**GE Hitachi Nuclear Energy**

MFN 08-339

**Subject: Response to Portion of NRC Request for Additional Information  
Letter Number 148 Related to ESBWR Design Certification  
Application – Seismic Category I Structures – RAI Numbers 3.8-4  
S03, 3.8-101 S03, 3.8-102 S03, and 3.8-103 S03**

**Figure 3.8-4 (1) Comparison in M-N interaction between ACI 349-01 and ASME 2004-Section III, Division 2**

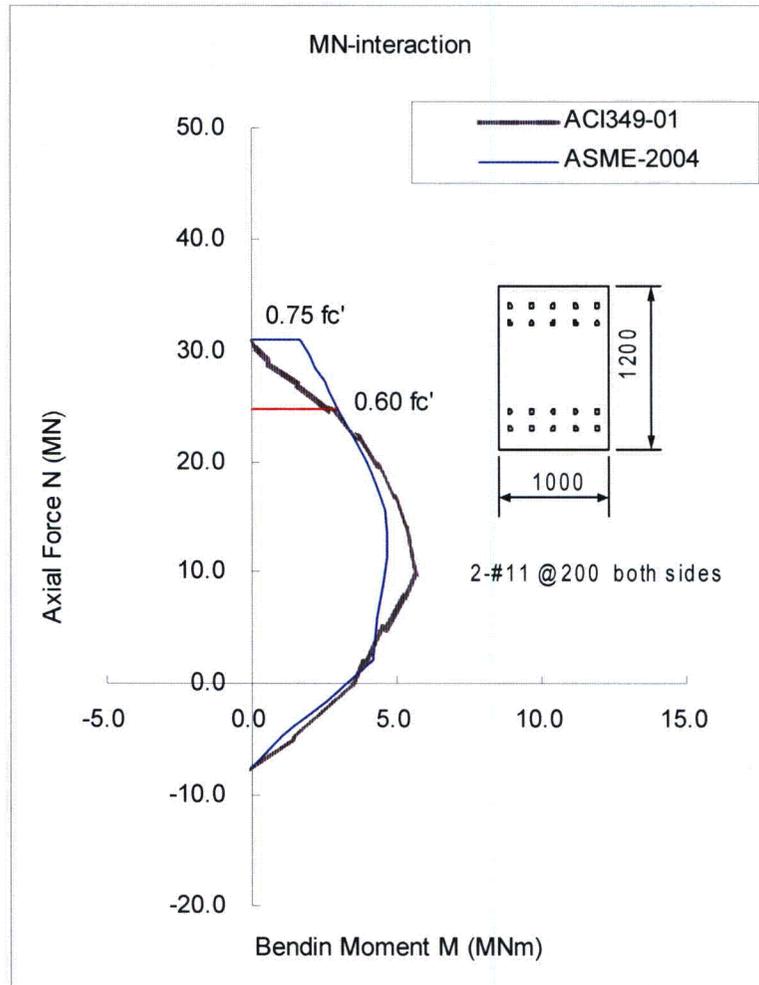
*During the audit, GE explained that the loads and load combinations for the entire RB from the ACI 349 and ASME Section III, Division 2 are checked against the acceptance criteria in ASME Section III, Division 2 Code. GE indicated that they have confirmed that the acceptance criteria in the ASME, Section III, Division 2 Code are more conservative than the acceptance criteria in ACI 349. GE was requested to provide the technical basis for this conclusion. Therefore, in effect the entire RB is designed to both the ASME Section III, Division 2, Subsection CC and the ACI 349 Code. In this case, the current boundary shown in DCD Figure 3.8-1 for the ASME jurisdictional boundary for all aspects of design, construction, fabrication, and inspection is acceptable. GE will provide a supplemental response to this RAI and RAIs 3.8-67, 101, 102 and 103 to reflect the above.*

Figure 3.8-4 (1) shows the comparison of M-N (bending moment-axial force) interactions that define the relationships between allowable bending moments and axial forces calculated in accordance with ACI 349-01 and ASME 2004 Section III, Division 2 codes (for factored primary and secondary loads).

As shown in Figure 3.8-4 (1), the ASME allowable values are smaller, except in the high axial force (compression) region in which the ASME limit is  $0.75f'_c$  for primary plus secondary membrane and  $0.60f'_c$  for primary membrane. For additional conservatism,

the  $0.60f'_c$  limit, which is lower than the ACI 349-01 allowable, is applied to the ESBWR design. Therefore, the use of the ASME acceptance criteria is a conservative design approach for the design of ESBWR concrete structures that are integrated with the containment.

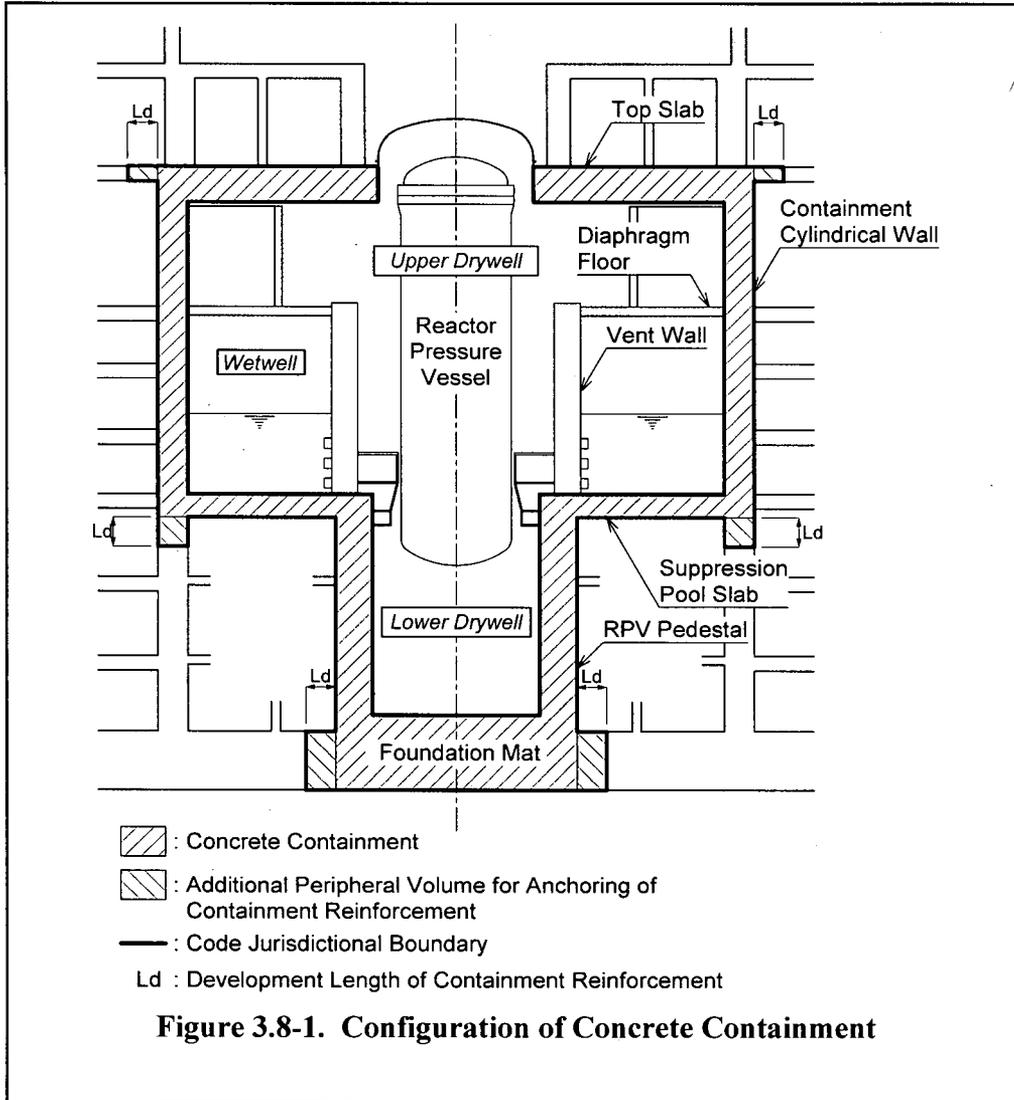
*Based on the above discussion, the ASME Code jurisdictional boundary for design, construction, fabrication, and inspection of the containment discussed in DCD Section 3.8.1 and as shown in DCD Figure 3.8-1 would also need to be revised. As noted in the Supplement 1 response to this RAI, Interpretation No. 12 (III-2-83-01) of ASME Code Section III states that when the containment mat is integral with other building foundations, only the portion of the containment foundation mat directly beneath the containment vessel including any additional peripheral volume for anchoring of the containment shell reinforcement shall be considered within the code jurisdictional boundary and constructed in accordance with the rules of ASME Code Section III, Division 2. Based on this interpretation, Section 3.8.1 of the DCD including Figure 3.8-1 also needs to be revised to indicate that where integral connections from the reactor building exist (i.e., base mat beyond the containment foundation mat directly beneath the containment vessel as well as floor and walls integrally connected to the containment) the additional peripheral volume for anchoring the containment shell reinforcement shall be within the Code jurisdictional boundary, and thus are subject to all of the rules in ASME Code Section III, Division 2.*

DCD Tier 2 Subsection 3.8.1, including DCD Tier 2 Figure 3.8-1, will be revised incorporating the statement of Interpretation No. 12 (III-2-83-01) of ASME Code Section III. The boundaries of the additional peripheral volumes are determined based on the required development lengths of containment reinforcements.

The configuration of the containment is shown in Figure 3.8-1. Additional peripheral volumes for anchoring of the containment reinforcements are considered within the code jurisdictional boundary and constructed in accordance with the rules of ASME Code Section III, Division 2. The boundaries of the additional peripheral volumes are determined based on the required development lengths of containment reinforcements. The key dimensions of the containment are summarized in Table 3.8-1.

The RB is designed to the more limiting acceptance criteria of the ASME Section III, Division 2, Subsection CC and ACI 349-01. The relevant acceptance criteria are allowable compressive stress in concrete, allowable tensile and compressive stresses in reinforcing steel, and allowable transverse shear stress for the design of RB concrete elements. For a combination of axial force and bending moment, the acceptance criteria of ASME Section III, Division 2, Subsection CC are more limiting than ACI 349-01 and are applied in the RB design. The acceptance criteria for transverse shear are essentially the same between ASME Section III, Division 2, Subsection CC and ACI 349-01. Therefore, the ACI-349-01 acceptance criteria for transverse shear are applied in the RB design. The aforementioned acceptance criteria is also applicable to the additional peripheral volumes for anchoring the containment reinforcement, which are shown in Figure 3.8-1.
